HISTORIC AND DESIGN REVIEW COMMISSION

May 01, 2019

HDRC CASE NO: 2019-237
ADDRESS: 1118 IOWA ST
LEGAL DESCRIPTION: NCB 3885 BLK 1 LOT 5
ZONING: RM-4,H
CITY COUNCIL DIST.: 2
DISTRICT: Knob Hill Historic District
APPLICANT: Steven Lopez
OWNER: Shalimar Maakar
TYPE OF WORK: Front porch modifications
APPLICATION RECEIVED: April 12, 2019
60-DAY REVIEW: June 11, 2019
CASE MANAGER: Stephanie Phillips
REQUEST:

The applicant is requesting a Certificate of Appropriateness for approval to replace existing non-original front columns with new tapered Craftsman-style columns.

Front Elevation

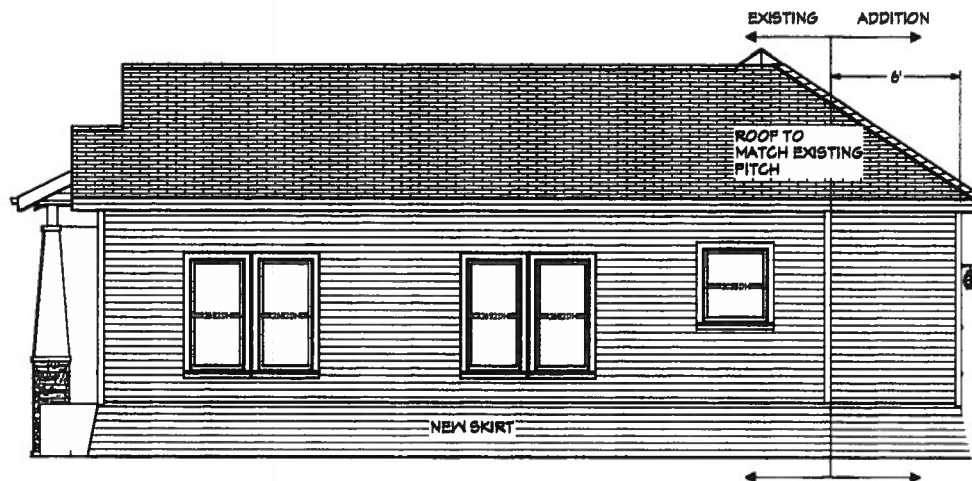
- b. **PORCH MODIFICATIONS** – The applicant has proposed to remove the existing non-original decorative wrought iron columns and install new tapered Craftsman-style columns with brick bases. The applicant has provided elevation drawings of the front façade, but has not yet indicated detailed dimensions of the proposed columns in plan or elevation. According to the Historic Design Guidelines, porches should be reconstructed based on accurate evidence of the original, such as photographs. If no such evidence exists, the design should be based on the architectural style of the building and historic patterns. The proposed design is generally reflective of Craftsman style porch detailing of the era. Staff finds the proposal appropriate with the stipulations listed in the recommendation.

Staff recommends approval of the column replacement based on finding b with the following stipulations:

- i. That the applicant provides a detailed and dimensioned plan and elevation drawings for the proposed columns for review and approval prior to receiving a Certificate of Appropriateness.
- ii. That the applicant provides all material specifications for review and approval prior to receiving a Certificate of Appropriateness.
